**Brisbane CBD BUG submission on Howard Smith Wharves  
development application - A006618899**

This submission provides the views of the Brisbane Central Business District Bicycle User Group (CBD BUG) on the Howard Smith Wharves (HSW) development application (DA) (A006618899).

**Figure 2 – REFER TO SHEET A-HO.016 OF THE ARCHITECTURAL DRAWING**

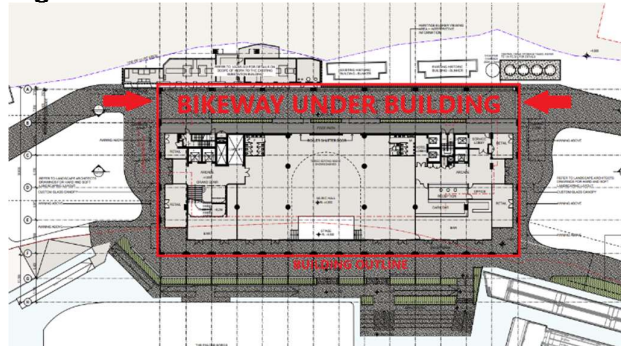
- This proposal in this DA for the new hotel to span the shared path (refer Figures 2 and 3) will impose even greater restrictions on the movement of active transport users travelling through this area via the public path. We call for this building’s envelope to be reduced so it has an appropriate set-back from the path – especially to remove the potential for people exiting doorways or stepping out from behind columns to be involved in crashes with people riding bicycles/scooters.

## Figure 6 - Clip from TMR, Road Design Part 6A

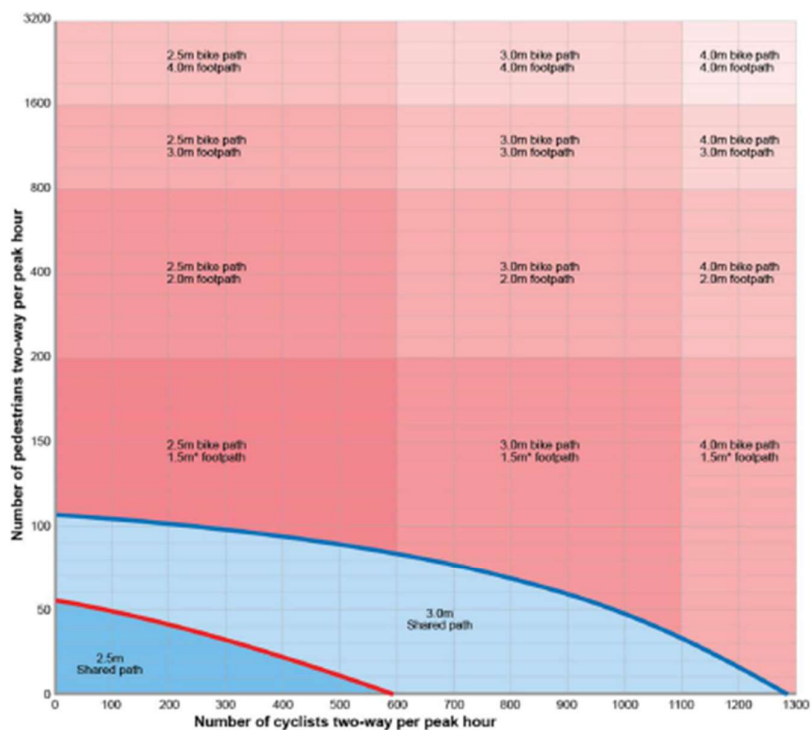
Based on the results of the CBD BUG’s shared path users count, patronage far exceeds the design parameters for a shared path (by 200%) as per TMR and AustRoads guidelines (refer Figure 6). It is unacceptable that the development should be permitted to yet again provide an active transport corridor that does not comply with the relevant guidelines.

1. Public access through the site to remain open 24/7 during demolition, construction and then on a continuous, ongoing basis for the replacement path, with all works via a minimum clear width of 5.0m for the temporary path at the current elevation.
2. Redevelopment to deliver a permanent, segregated path in accordance with Austroads and TMR guidelines - comprising a minimum 3.5m wide path for pedestrians and 4.0m wide path for bicycle /scooter riders. Surface treatment to clearly define segregated nature of path in accordance with similar paths in Brisbane.
3. Services e.g. waste bins and all vehicles to be prevented from using the paths and as a very minimum outside of peak commuter times i.e. 7-9am 3-7pm
